FIRST AMENDMENT TO DEVELOPMENT AGREEMENT

STAFF REPORT
COMMUNITY DEVELOPMENT DEPARTMENT

HEARING DATE: 8/22/2023
 TO: Mayor & City Council
 FROM: Sonya Allen, Associate Planner
 208-884-5533
 SUBJECT: Sessions Parkway - MDA
[H-2023-0030](#)
 LOCATION: 2700 N. Eagle Rd., in the NW 1/4 of
 Section 4. T.3N., R.1E. (Parcel
 #S1104233650)

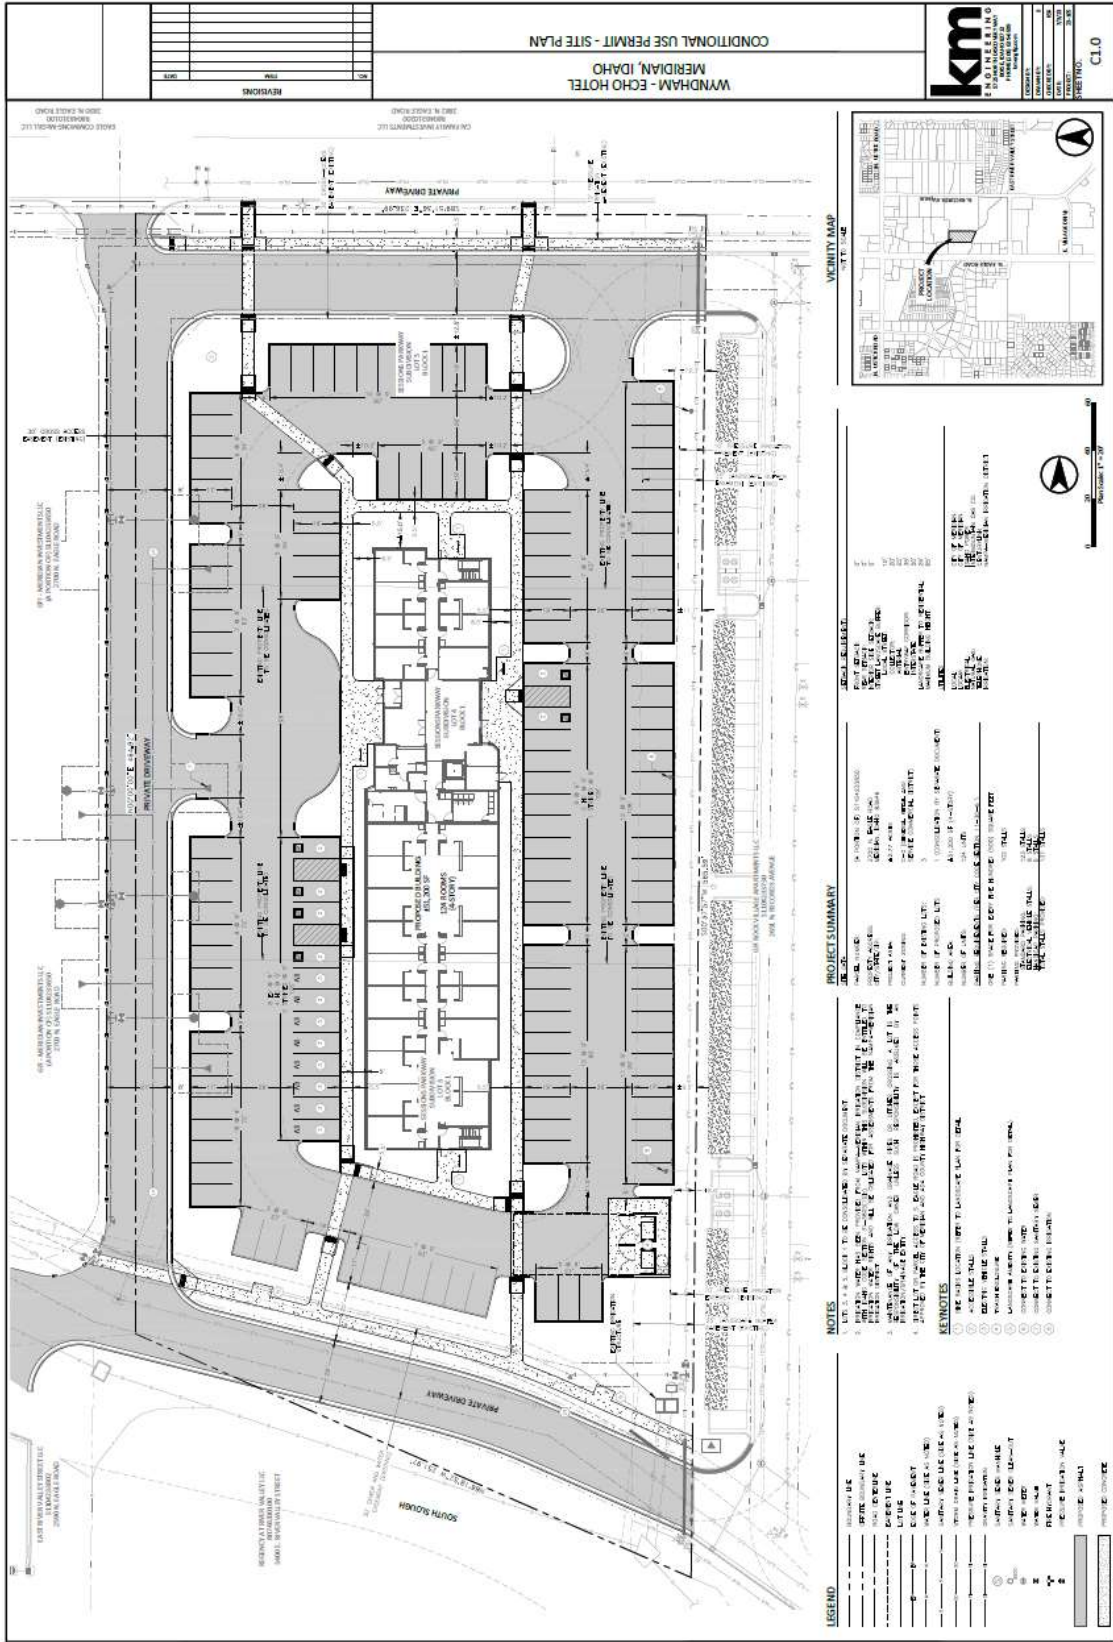
~~#5.1a.iii – If the site develops consistent with concept plan option 2, (The applicant shall construct a minimum 5-foot wide sidewalk on along the east side of the north/south drive aisle boundary through the site (instead of along the east boundary of the site as shown on concept plan) and provide a decorative crosswalks across the where pedestrian walkways cross internal drive aisles. Pedestrian walkways shall be provided at the east boundary of the site to of the multi-family portion of the development (NWC and SWC of the Village Apartments) to enhance pedestrian connectivity.~~

#5.1b – The subject property shall be subdivided prior to ~~submittal~~ issuance of the first second Certificate of Zoning Compliance application building permit for the site; subsequent building permit applications shall not be submitted until after the property is subdivided. Certificate of Zoning Compliance and Design Review applications may be submitted and approved prior to recordation of the plat.

#5.1c – A ~~minimum 25-foot~~ 5-foot wide buffer shall be installed along the eastern boundary of the site adjacent to the future residential uses as approved by City Council, landscaped per the standards listed in UDC 11-3B-9C, unless otherwise ~~modified by City Council~~ approved through alternative compliance. Construction of the buffer may take place with lot development.

#5.1h – Prior to issuance of the first Certificate of Occupancy within the development, all of the required street buffer landscaping along N. Eagle Rd./SH-55, including the 10-foot wide multi-use pathway and pedestrian lighting; and the backage road along N. Eagle Rd./SH-55, from the north to the south boundary with connections to N. Eagle Rd./SH-55 and the development to the east, shall be completed.
